Access Compliance Report

Public Rights-of-Way

Main Street: **DARWIN_AVE** Cross Street: **CEDARWOOD_AVE** Location: **SE**

ADA ID: **RPRK211005180102** Ramp Type: **Type 1 - Perpendicular Diagonal** Initial Pass/Fail: **Fail** Overall Compliance: **No** Severity Score: **15**

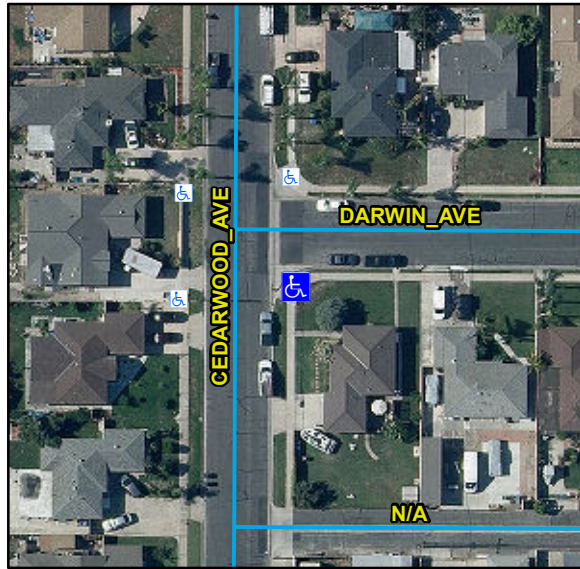
Compliance	Description	Data	Compliance	Description	Data
N/A	Ramp Length (in)	92	N/A	Flare Type LT	
Yes	Ramp Width (in)	48			N/A
No	Ramp Run Slope (%)	11.1	N/A	Flare Slope LT (%)	N/A
Yes	Ramp Cross Slope (%)	0.8	N/A	Flare Traversable LT	N/A
N/A	Landing Present	N/A	N/A	Flare Type RT	
N/A	Landing Length (in)	N/A			N/A
N/A	Landing Width (in)	N/A	N/A	Flare Slope RT (%)	N/A
N/A	Landing Run Slope (%)	N/A	N/A	Flare Traversable RT	N/A
N/A	Landing Cross Slope (%)	N/A	N/A	DWS Provided	N/A
N/A	Landing Movement Obstructed?	N/A	N/A	DWS Contrast	N/A
	Landing Movement Type	N/A	N/A	DWS Length (in)	N/A
N/A	Landing Shared	N/A	N/A	DWS Full Width	N/A
N/A	Clear Space	Yes	N/A	DWS Offset Left (in)	N/A
N/A	Clear Space To Crosswalk (in)	N/A	N/A	DWS Offset Right (in)	N/A
N/A	Marked Crosswalk 1	No	N/A	Marked Crosswalk 2	No
	Crossing 1 Direction	N		Crossing 2 Direction	W
	Marked Crosswalk 1 Width (in)	N/A		Marked Crosswalk 2 Width (in)	N/A

N/A	Ramp Inside Crosswalk 1	N/A	Yes	Ramp Inside Crosswalk 2	N/A
	Crossing 1 Slope (%)	4.8		Crossing 2 Slope (%)	3.2
	Crossing 1 Cross Slope (%)	2.8		Crossing 2 Cross Slope (%)	1.3
N/A	Gutter Ponding	N/A	No	Curb Slope	15.7
Yes	Gutter Lip Height (in)	0		Road Run Slope (%)	2.9
N/A	Gutter Run Slope (%)	N/A		Road Cross Slope (%)	4
N/A	Gutter Cross Slope (%)	N/A			
Yes	Overall Surface Condition: Acceptable		Yes	Perp Joint Present	Yes
	Cross Gutter Present?	Yes		Spandrel Present?	Yes
	Replace Cross Gutter?	No		Replace Spandrel?	No

Remove & Replace Curb Ramp With Two New Directional Ramps or Equivalent.

R304.2.2, STD 1115
